CITY OF PROVIDENCE, RHODE ISLAND

RFP Title: HVAC and Electrical Upgrades at 2 Fire Stations

Addendum #: 6

NORTH MAIN STREET FIRE STATION - HVAC & ELECTRICAL UPGRADES

8 SAFETY SHUT OFF VALVE BOX
M601 NOT TO SCALE

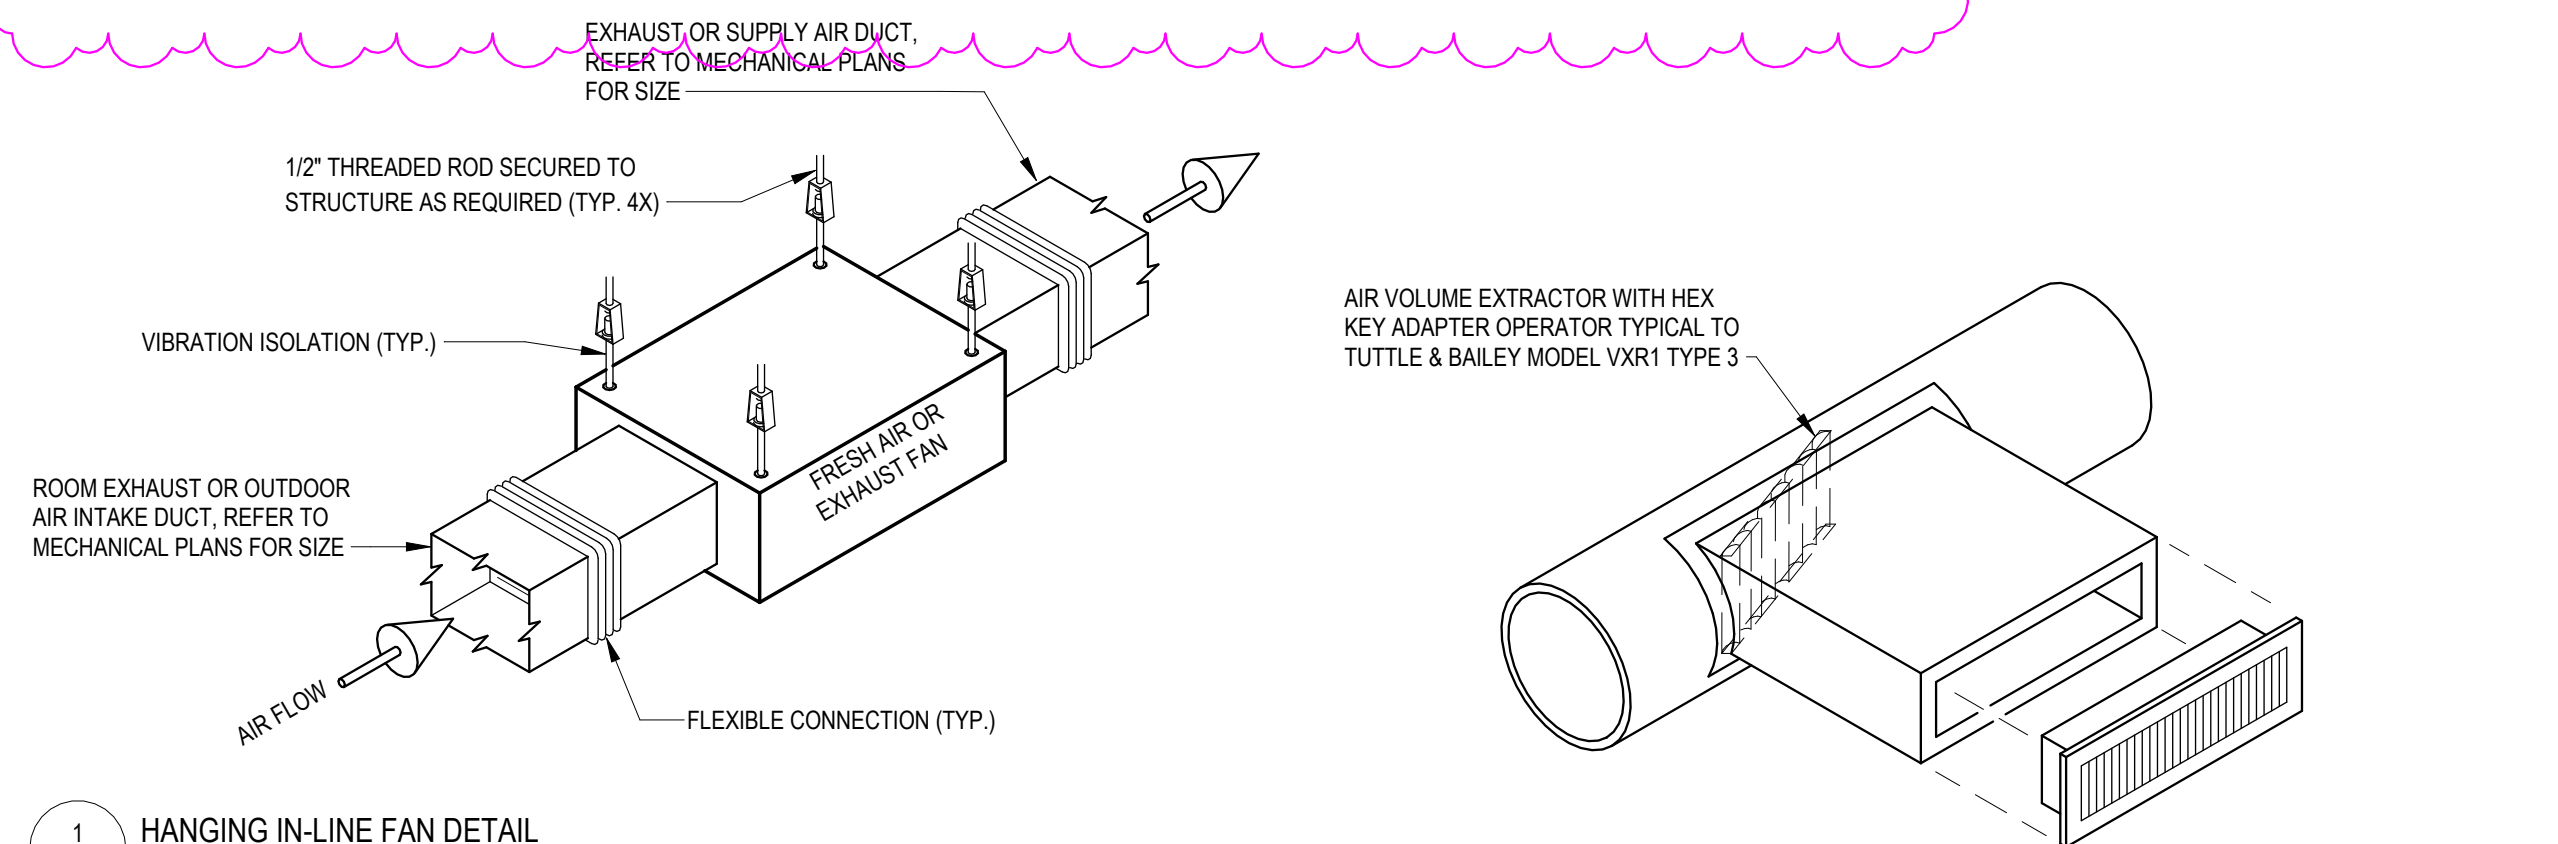
During review of bidder questions, our design team at Creative identified a correction that needed to be made to the drawings at North Main. They identified that there are two additional 208V boxes required for safety shutoff valves to comply with code requirements. Creative have provided updated drawings showing the two added boxes which are attached here for bidders to update their bids.
